**GRID CODE
CONSULTATION DOCUMENT**

**Grid Code Requirements for Power Park Modules –
Voltage Control and Reactive Power**

Consultation Ref	B/08
Issue	1.0
Date of Issue	23 May 2008
Responses required by	23 June 2008
Prepared by	National Grid

Figure 4

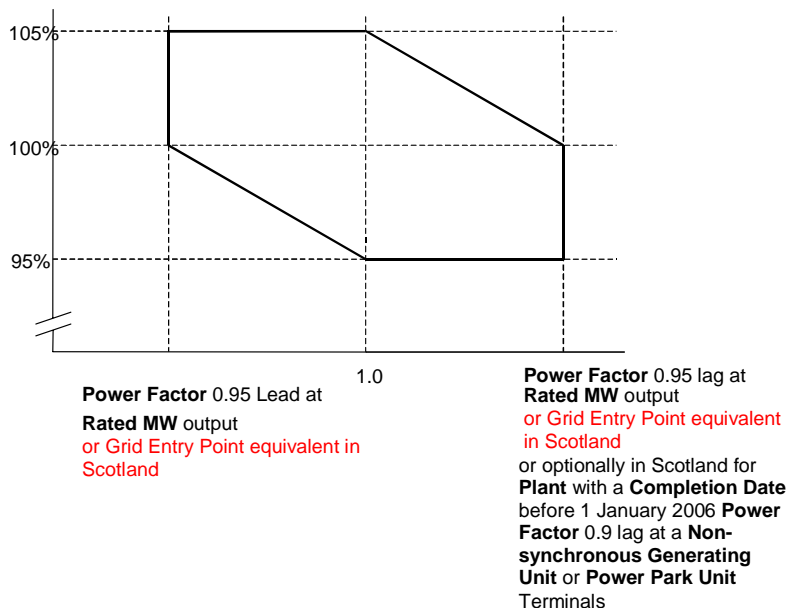
- 8.3 The text of CC.6.3.4 has been modified appropriately in revision 26. However, the title of Figure 4 and the labels on the reactive power output have not been modified and are inconsistent with the text of C.6.3.4 and the reactive capability requirements of CC.6.3.2(c). The title still refers to England and Wales rather than the whole of the GB transmission system and the axis does not reflect the fact that, in Scotland, the reactive power capability requirement of 33kV connected generation is specified at the HV side of the transformer rather than the Grid Entry Point and may not be 0.95 power factor lead/lag at the Grid Entry Point.

- i. The title of Figure 4 refers to the Grid Entry Point rather than the Grid Entry Point in England and Wales;
- ii. The reactive power axis labels of Figure 4 acknowledge that the Grid Entry Point requirement in Scotland may not be 0.95 power factor lead/lag;
- iii. The text of CC.A.7.2.2.4 applies the relaxations to the whole GB transmission system rather than England and Wales; and
- iv. The text of clause CC.A.7.2.2.7 requires the generator to maintain maximum leading reactive current output for voltage rises above 105%.

Voltage at **Grid Entry Point** in England and Wales or **User System Entry Point if Embedded** (% of Nominal) at 33 kV and below
